X3T9.2/87-9

16-bit SCSI Example Block Diagram*

Proposed Wording to Sec. 5.1.5.3 (add to last paragraph)

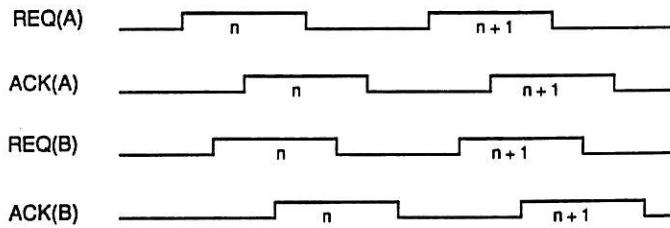
* Only immediate SCSI data paths are shown. Other elements are needed for a complete system.

16/32-bit Async. Handshake Relative Timing of Req/Ack(A) and Req/Ack(B)

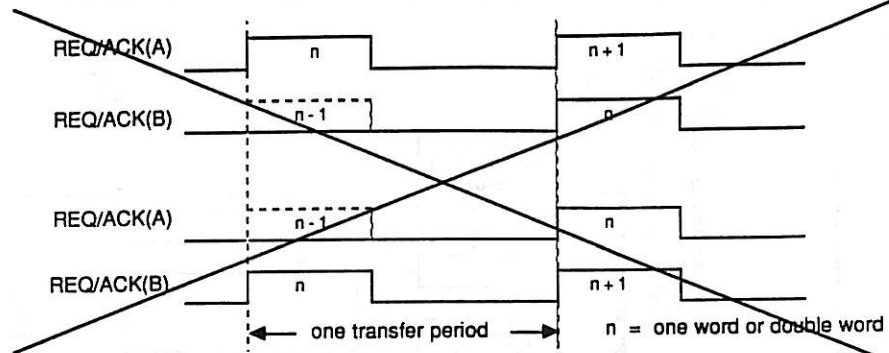
In asynchronous mode, both Requests must be asserted before asserting an Acknowledge on either cable.

Likewise, both Acknowledges must be deasserted before another Request can be asserted on either cable.
